SUBWAY TV MEDIA SYSTEM

UNITED STATES PATENT AND TRADEMARK OFFICE

Figure 2 of Minesaki

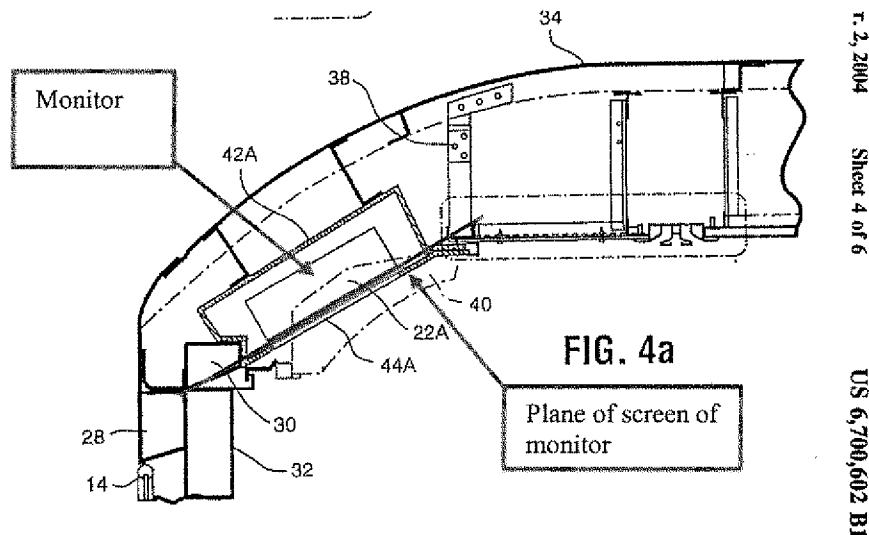
As can be seen, there is not a single part of the information transmission display (part J) illustrated in Figure 2 which can reasonably be considered to be flush with the adjacent wall surface (as Patent Owner has used that term in its specification and Claim 1); in fact, the entire information

transmission display part J of Minesaki clearly protrudes away from the adjacent wall surface. Patent Owner refers the Office to FIG. 4a of its specification (reproduced below for convenience), which clearly shows an embodiment of Patent Owner's invention that has a screen that is substantially flushed with the adjacent wall surface (as explicitly recited in Claim 1), and with no protrusion of the display (as occurs in Minesaki). As indicated in Patent Owner's specification regarding FIG. 4a, this configuration gives a better aesthetic appearance to the inside of the subway car as a whole, as well as improving the display performance by minimizing the interference effects.

Figure 4 of Amano

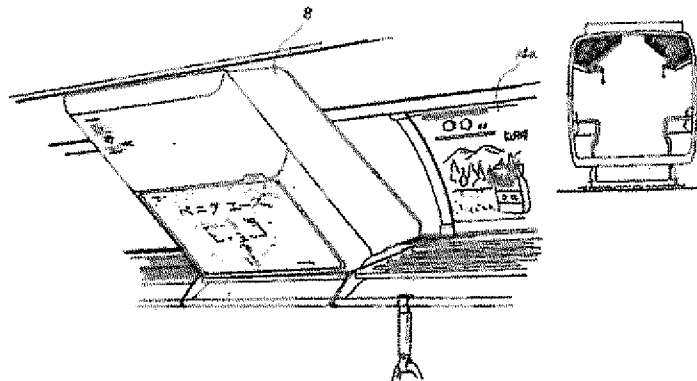
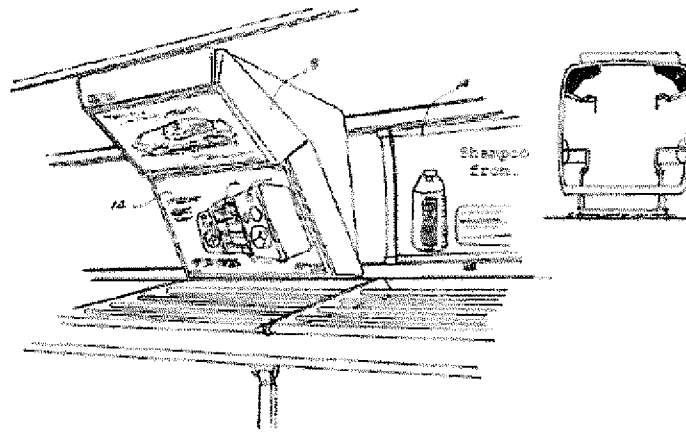
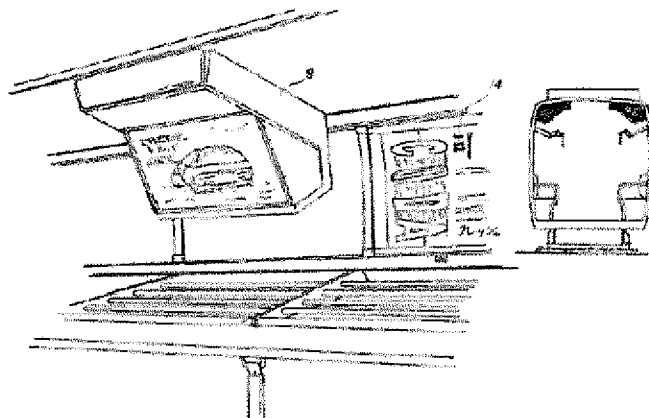
10 **Claim 1** – With regards to the Office’s rejection of Claim 1 as being anticipated by Amano, Patent Owner respectfully traverses. Specifically, Patent Owner respectfully submits that Amano fails to expressly or inherently describe “the screen of the monitor substantially flushed with the adjacent wall surface structure of the car”.

15 Again, the Office alleges that the term “substantially” is often used in conjunction with another term to describe a particular characteristic of the claimed invention and is further construed to be a broad term (citing MPEP §2173.05). Again, Patent Owner respectfully submits that the use of the term “substantially” cannot be construed so broadly as to read the term “flushed” completely out of the claim. Figures 4 – 6 of Amano are reproduced below for the convenience of the Office.

Figure 2 of Maekawa

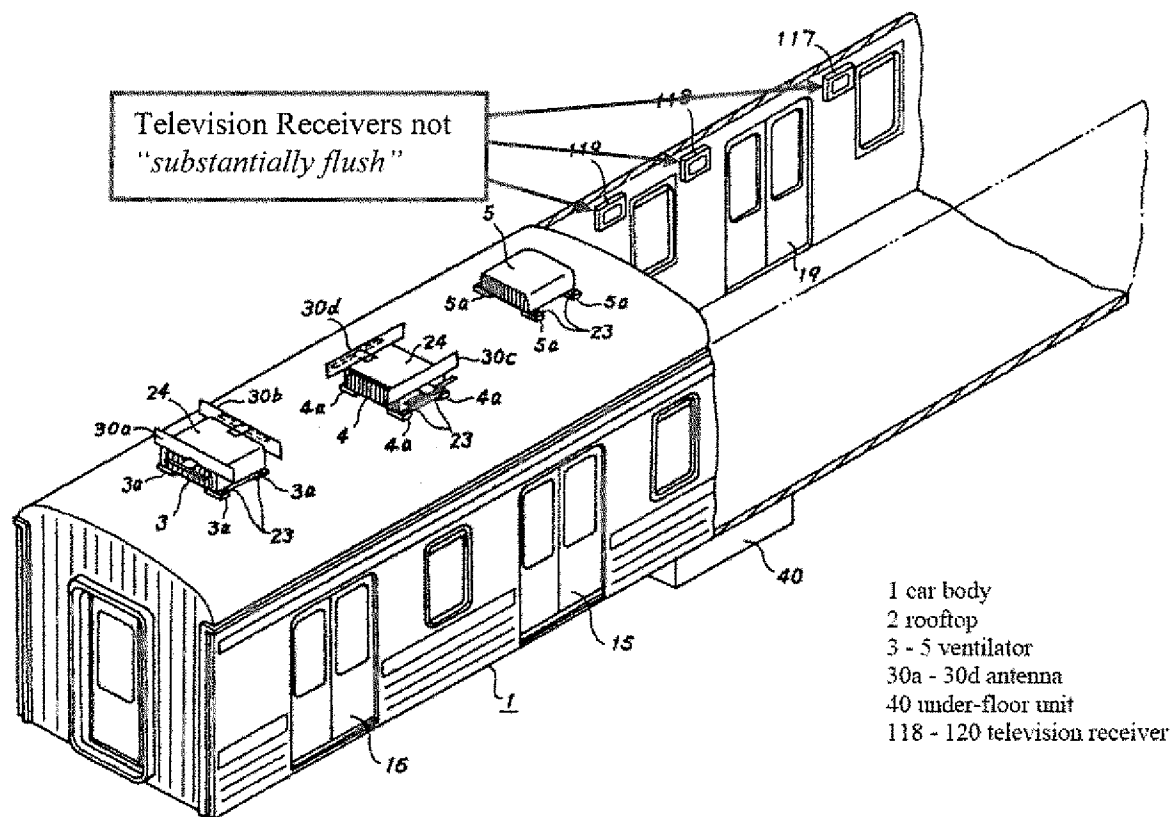
As can be seen, there is not a single part of the television receiver illustrated in Figure 2 (including especially its screen) that is flush with the adjacent wall surface structure of the car; in fact, the entire television receiver of Maekawa clearly protrudes from the adjacent car wall surface. Accordingly, Patent Owner respectfully submits that the Office's interpretation of the term "substantially flushed" is improper, as the Office's interpretation completely reads out the "flushed" feature.

Figure 4 of Amano

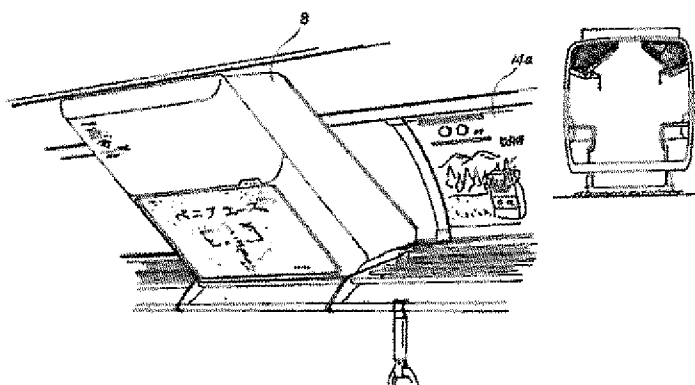
10 In the instant case, Amano fails to teach or suggest "the screen of the monitor [being] substantially flushed with the adjacent wall surface structure of the car". However, the Office states that the monitor of Amano can readily and predictably be substituted with the flush monitor of Moore. To the contrary, Patent Owner respectfully submits that the wall structure of Amano (in particular, the area near the junction of the sidewall and ceiling) would need to be appreciably modified in order to accommodate a flush monitor. See also, for example, FIG. 4a
15 of the '602 Patent. However, Amano also illustrates storage areas on the upper areas of the train. See for example, Figure 4 of Amano reproduced below.

20 Accordingly, modifications to the area near the junction of the sidewall and ceiling of the Amano train would render the Amano train unsatisfactory for its intended purpose. For example, if the wall surface structure near the information display device 8 were to be extended so that the screen of the information display device 8 were "substantially flushed" with its adjacent walls, the storage areas would need to be substantially reduced in size or eliminated entirely. It

FIG. 4a

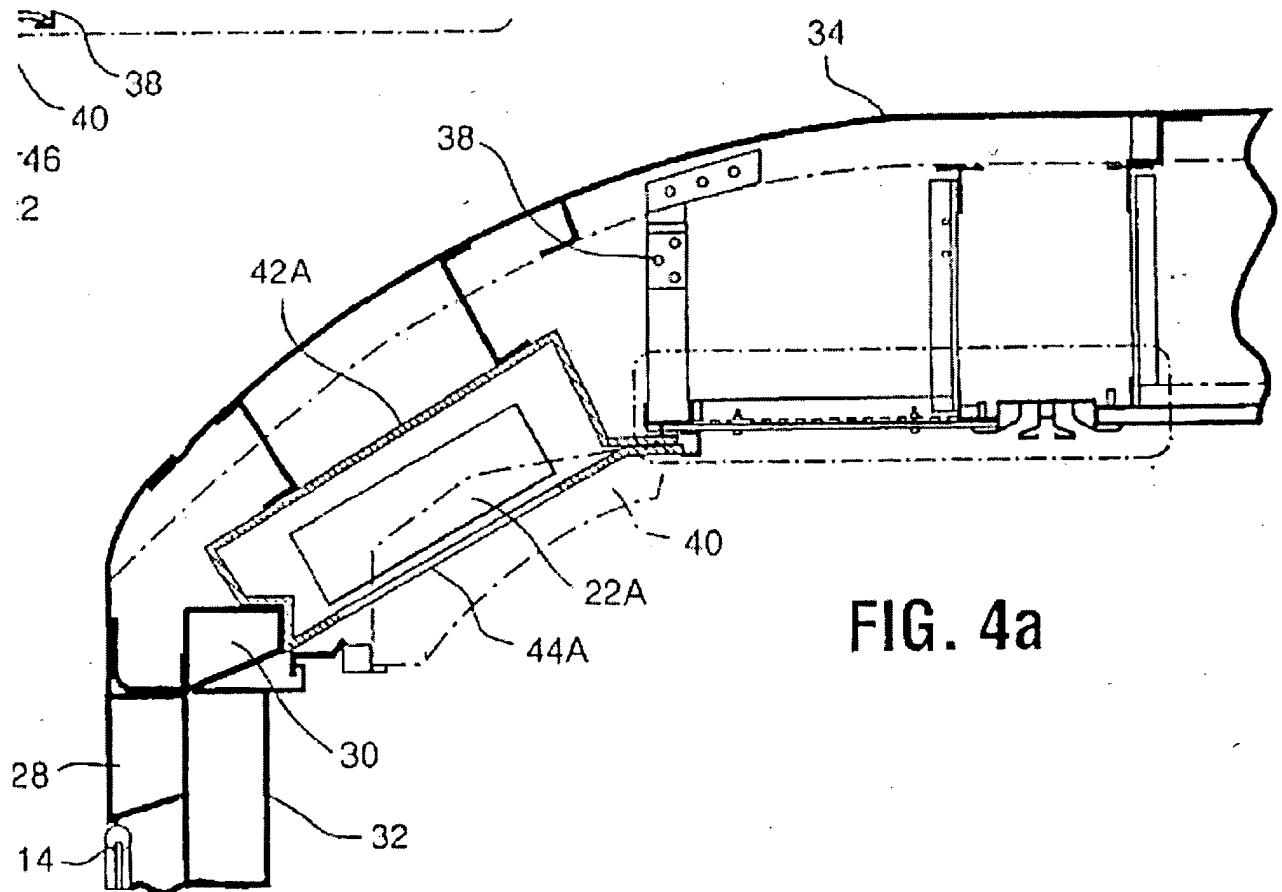
An alternative embodiment is illustrated in FIG. 4A, a view similar to that of FIG. 4. In this alternative embodiment, CRT video monitor 22 is replaced with an LCD-based video monitor 22A which is of thin, rectangular cross-section, and occupies less space in the ceiling structure of the car. Accordingly, it can be moved towards the ceiling so that its viewing screen is substantially flush with or even behind the light panel 40. This use of an LCD-based monitor gives a better aesthetic appearance to the inside of the subway car as a whole, as well as improving the display performance by minimizing the interference effects, as previously discussed. (Page 5, lines 35-46)

Minesaki further discloses such a configuration in the annotated Figure 2, as shown below

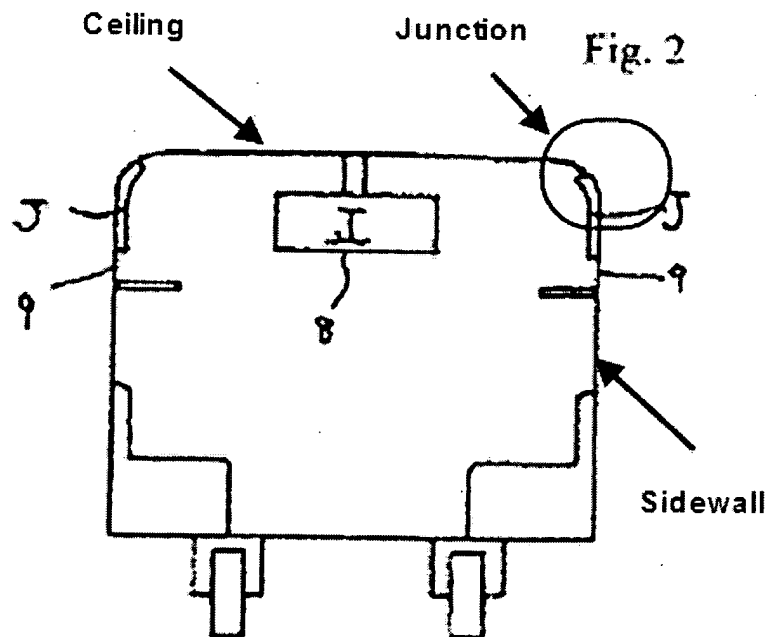
29. With respect to Owners reply/argument that Minesaki fails to expressly or inherently describe "each of said monitor being mounted at the junction of the sidewall and ceiling", the examiner respectfully disagrees. As Owner has noted, Minesaki discloses

This information transmission display part J may also be formed on the sidewall of the train car (page 590, right upper most column).

Figure 2 of Minesaki

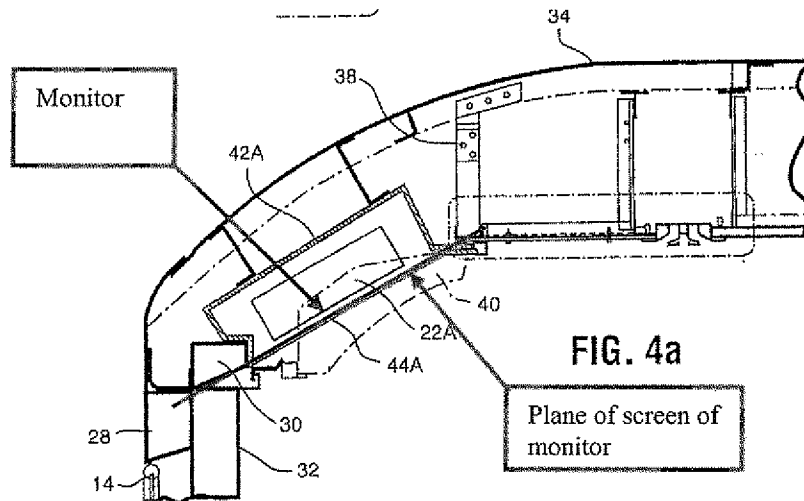
As can be seen, there is not a single part of the information transmission display (part J) illustrated in Fig. 2 which can reasonably be considered to be flush with the adjacent wall surface (as Patent Owner has used that term in its specification and Claim 1); in fact, the entire information transmission display part J of Minesaki clearly protrudes away from the adjacent wall surface. Patent Owner refers the Office to FIG. 4a of its specification (reproduced below for convenience), which clearly shows an embodiment of Patent Owner’s invention that has a screen that is substantially flushed with the adjacent wall surface (as explicitly recited in Claim 1), and with no protrusion of the display (as occurs in Minesaki). As indicated in Patent Owner’s specification regarding FIG. 4a, (See, e.g. Col 5, lines 42 – 45 of Patent Owner’s specification) this configuration gives a better aesthetic appearance to the inside of the subway car as a whole, as well as improving the display performance by minimizing the interference effects.

Figure 2 of Maekawa

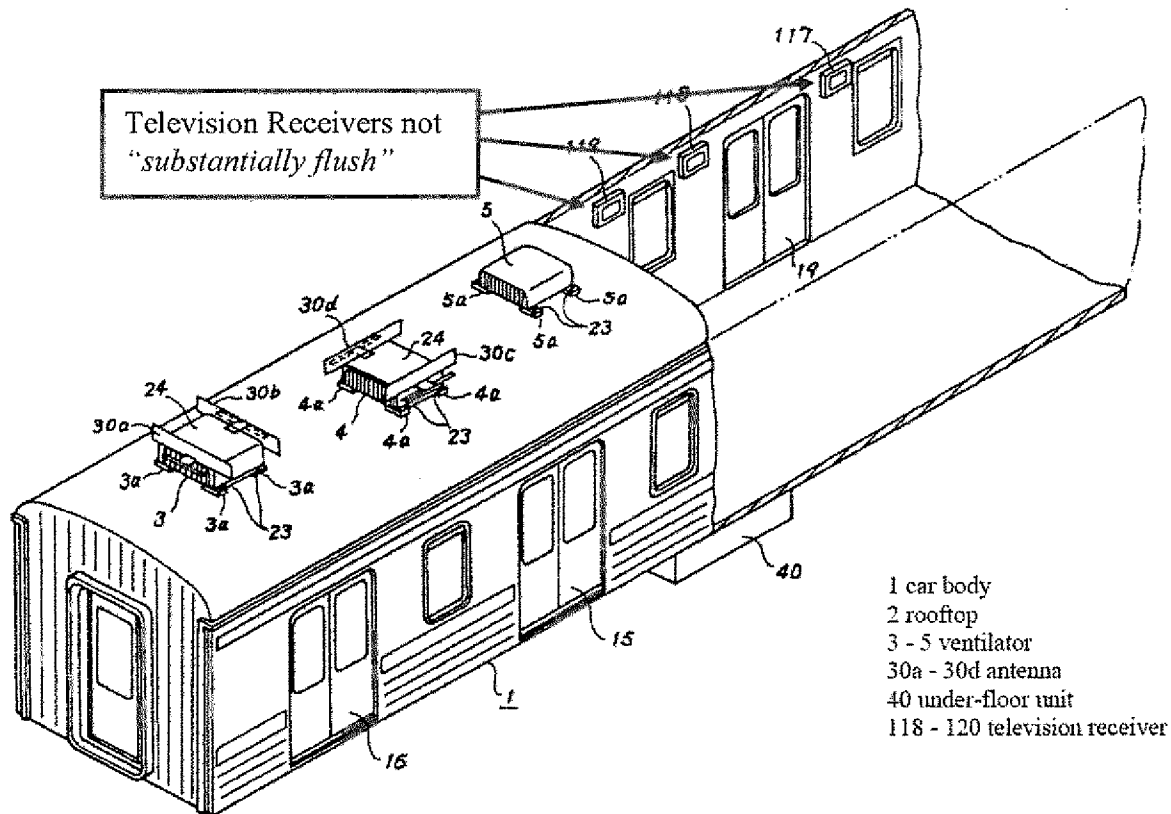
As can be seen, there is not a single part of the television receiver illustrated in Figure 2 (including especially its screen) that is flush with the adjacent wall surface structure of the car; in fact, the entire television receiver of Maekawa clearly protrudes from the adjacent car wall surface, or sits on top of the adjacent wall surface, by an amount roughly equal to the thickness of the wall itself. Accordingly, Patent Owner respectfully submits that the Office’s interpretation of the term “substantially flushed” is improper, as the Office’s interpretation completely reads out the “flushed” feature.

Issue 1: Rejection of Claim 1 under 35 under 35 U.S.C. 102 as Being Anticipated by Minesaki

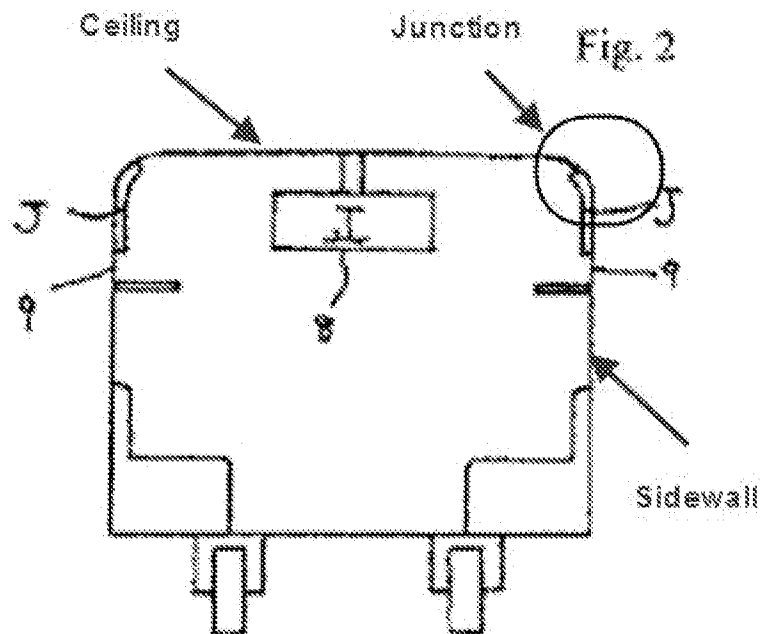
With respect to Appellant's reply/argument that Minesaki fails to expressly or inherently describe "each of said monitor being mounted at the junction of the sidewall

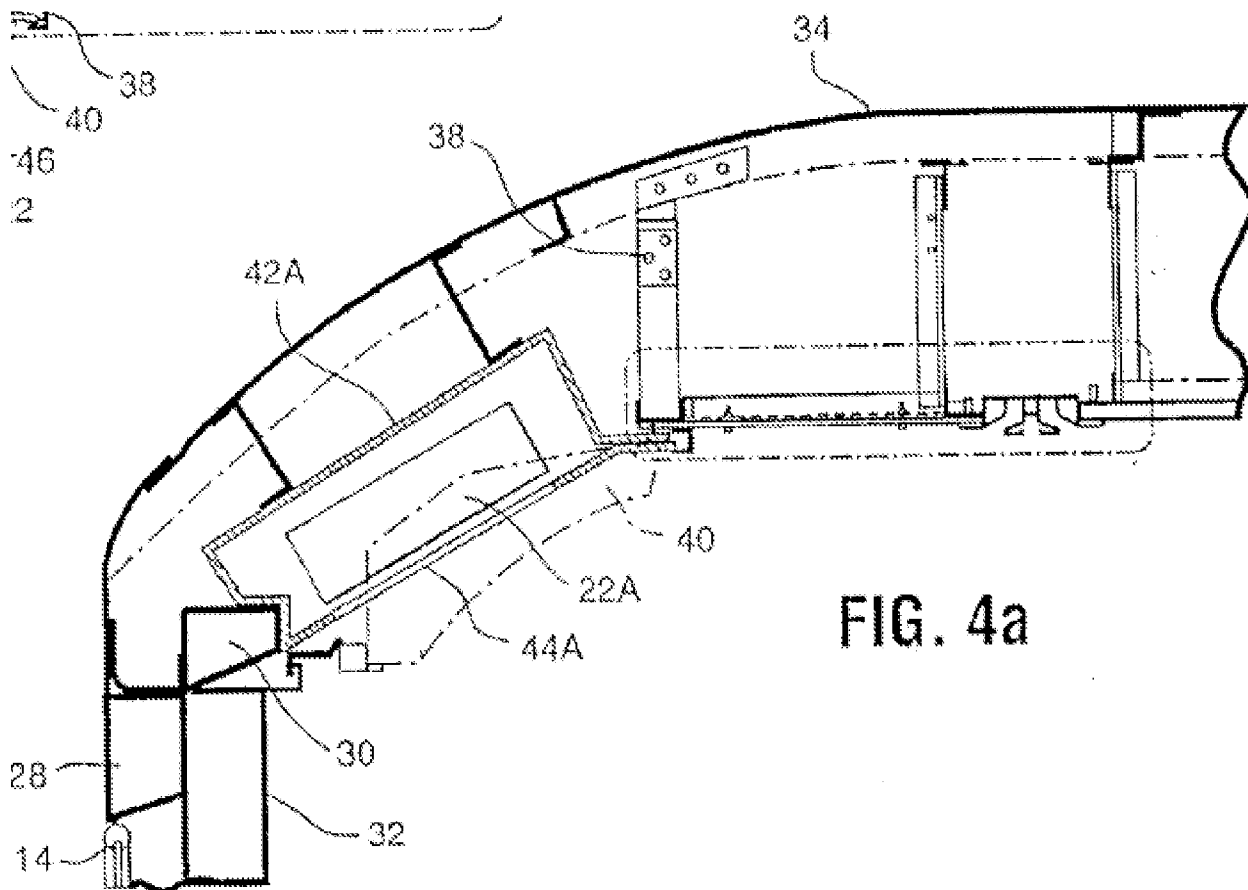
(T)he term “substantially” is often used in conjunction with another term to describe a particular characteristic of the claimed invention. It is a broad term. (See MPEP 2173.05).

The recitation to “flush” is modified by the term “substantially” which essentially broadens the recitation of “flush”. The term “flush” is examined as “forming a continuous plane or unbroken surface.”¹ The limitation of “substantially flushed” recites the screen of the monitor not forming a continuous plane or unbroken surface, but to the screen *not wholly forming* a continuous plane or unbroken surface with the adjacent wall surface structure. Appellant discloses

An alternative embodiment is illustrated in FIG. 4A, a view similar to that of FIG. 4. In this alternative embodiment, CRT video monitor 22 is replaced with an LCD-based video monitor 22A which is of thin, rectangular cross-section, and occupies less space in the ceiling structure of the car. Accordingly, it can be moved towards the ceiling so that its viewing screen is substantially flush with or even behind the light panel 40. This use of an LCD-based monitor gives a better aesthetic appearance to the inside of the subway car as a whole, as well as improving the display performance by minimizing the interference effects, as previously discussed. ('602 patent; page 5, lines 35-46)
